CPSES-200602340  
Log # TXX-06189  
File # 00236

**SUBJECT:** COMANCHE PEAK STEAM ELECTRIC STATION (CPSES)  
DOCKET NOS. 50-445 AND 50-446  
LICENSE AMENDMENT REQUEST (LAR) 06-012,  
REVISION TO TECHNICAL SPECIFICATION (TS) 3.7.5,  
"AUXILIARY FEEDWATER (AFW) SYSTEM," TS 3.8.1, "AC  
SOURCES - OPERATING," TS 3.8.9, "DISTRIBUTION SYSTEMS -  
OPERATING," AND TS EXAMPLE 1.3-3"

**ENCLOSURE 1 to TXX-06189**  
**DESCRIPTION AND ASSESSMENT**

**Example 1**

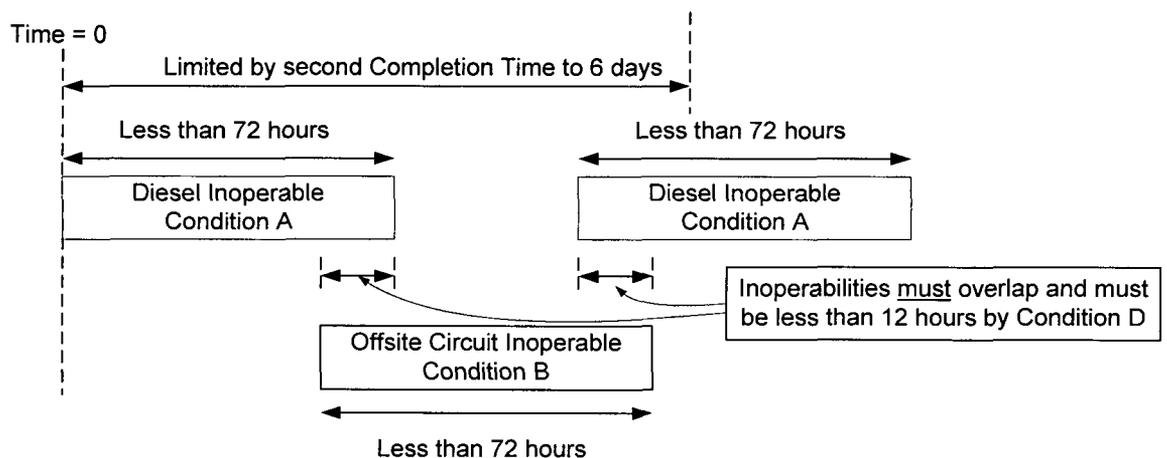
Specification 3.8.1, AC Sources - Operating, has a 72 hour Completion Time for one offsite circuit inoperable (Condition A) and a 72 hour Completion Time for one diesel generator inoperable (Condition B). Both Condition A and Condition B have a second Completion Time of “6 days from discovery of failure to meet the LCO.” The second Completion Time limits plant operation when Condition A or B is entered, and before the inoperable system is restored, the other Condition is entered, and then the first inoperable system is restored, and before the remaining inoperable system is restored, the other Condition is entered again. This highly improbable scenario is further limited by Condition D which applies when an offsite circuit and a diesel generator (DG) are inoperable. It limits plant operation in this Condition to 12 hours. See Example 1 for an illustration.

As stated above, the ROP monitors the availability of mitigating systems, including the emergency AC sources (DG unavailability). Such frequent,

repeated failures of the AC sources would be reported to the NRC and this represents a strong disincentive to such operation.

**Example 2**

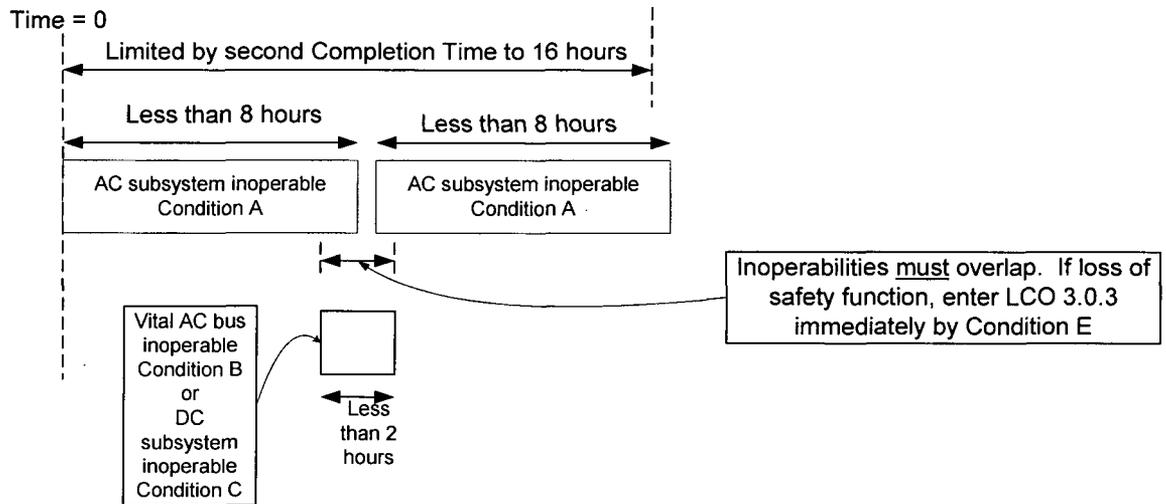
Specification 3.8.9, Distribution Systems - Operating, has an 8 hour Completion Time for one or more AC electrical power distribution subsystems inoperable (Condition A), and a 2 hour Completion Time for one or more AC vital buses (Condition B) or one or more DC electrical power subsystems (Condition C) inoperable. Conditions A, B, and C have a second Completion Time of 16 hours from discovery of failure to meet the LCO. Condition E applies if two or more electrical distribution subsystems are inoperable and, if it results in a loss of safety function, LCO 3.0.3 must be entered immediately. See Example 2.

The second Completion Time is not needed. First, it is unusual for an AC electrical power subsystem or AC vital bus to be inoperable without causing a reactor trip. Secondly, Completion Times are very short (8 and 2 hours) providing little time to restore systems such that the Conditions overlap and multiple inoperabilities occur. Lastly, should any overlapping inoperabilities that result in a loss of safety function occur, a plant shutdown in accordance with LCO 3.0.3 is required.

**Example 3**

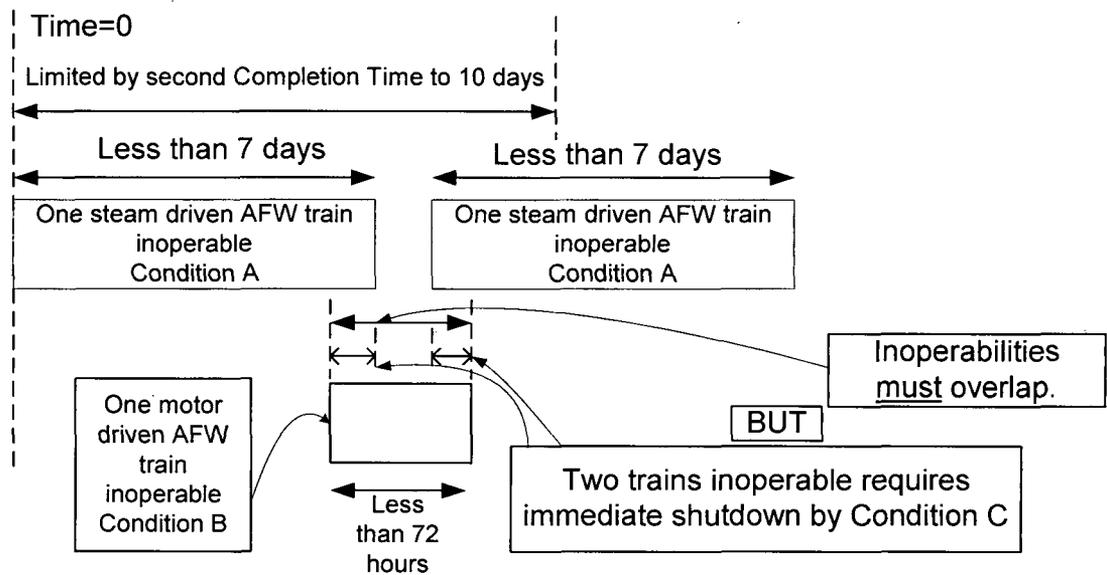
TS 3.7.5, Auxiliary Feedwater System has a 7 day Completion Time for one inoperable steam supply to a turbine driven AFW pump (rendering the turbine

driven AFW pump inoperable) (Condition A) and a 72 hour Completion Time for one AFW train inoperable (Condition B). Conditions A and B have a second Completion Time of 10 days from discovery of failure to meet the LCO. In order for the second Completion Time to be limiting, entry into and out of Conditions A and B must occur, which requires the turbine driven and motor driven AFW pumps to be concurrently inoperable. However, Condition C states that if AFW trains are inoperable the plant must be in MODE 3 in 6 hours and MODE 4 in 18 hours. See Example 3.

The second Completion Time is not needed. For the second Completion Time to be limiting, Conditions A and B must be entered concurrently. However, Condition C requires an immediate shutdown when two trains are inoperable. Therefore, the second Completion Time will never be limiting and can be removed. In addition, the ROP monitors the availability of the AFW system. Such frequent, repeated failures of the AFW system would be reported to the NRC and this represents a strong disincentive to such operation.
